PRODUCT/PROCESS CHANGE NOTICE (PCN)

PCN #: TB-0510-02	DATE: 29-Nov-2005	MEANS OF DISTINGUISHING CHANGED DEVICES:
Product Affected: 48L Cerpack & 84L Flatpack (Refer to Attachment II for affected parts)		☐ Product Mark ☐ Back Mark ☐ Date Code ☒ Other
Date Effective: 29-Dec-2005		Change in carrier color

ATTACHMENT I - PCN #: TB-0510-02

48L Cerpack Carrier

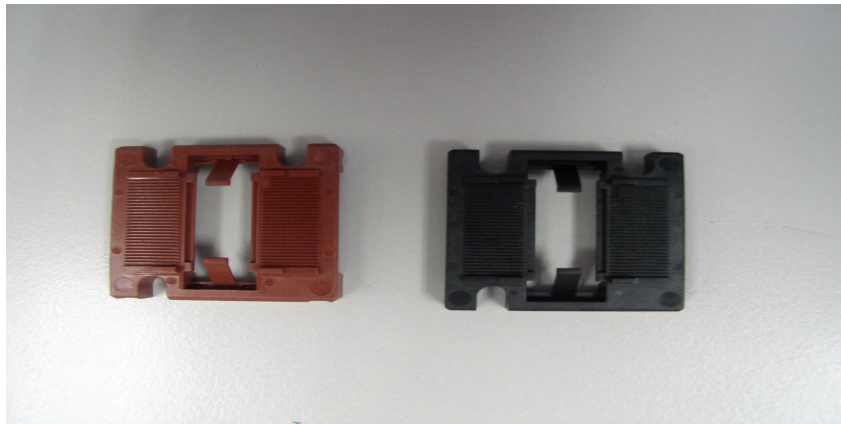
Detail of Change: There is no change in dimension for new carriers except for the color of carriers. For 48L Cerpack, carrier will be changed from red color to black color. For 84L Flatpack, carrier including carrier clip will be changed from green color to black color.
